**Public Comment No. 974-NFPA 70-2021 [Global Input]**

The Correlating Committee directs the Chair of CMP-12 to assign a task group to review all the definitions under their purview for compliance with the NEC Style Manual and to review definitions identified by the Correlating Committee that may contain correlation issues. The attachment includes a list of those definitions identified that need to be reviewed.

**Correlating Committee Note No. 361-NFPA 70-2021 [Global Input]****Supplemental Information**

CMP-12 - Definitions

Figure Informational Note Figure 620.1, No. 5 Control System.

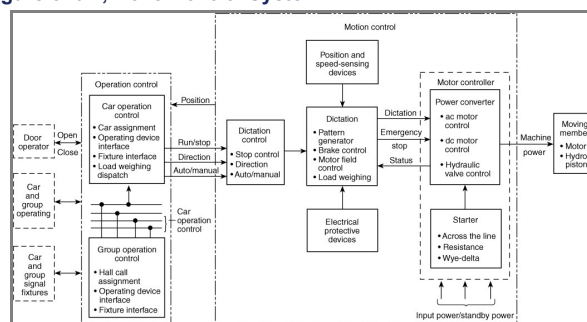
The Correlating Committee advises that article scope statements are the responsibility of the Correlating Committee and directs the Panel to revise the Informational Notes to comply with 4.1.3 of the NEC Style Manual.

Committee Statement: The Correlating Committee advises that article scope statements are the responsibility of the Correlating Committee and directs the Panel to revise the Informational Notes to comply with 4.1.3 of the NEC Style Manual.
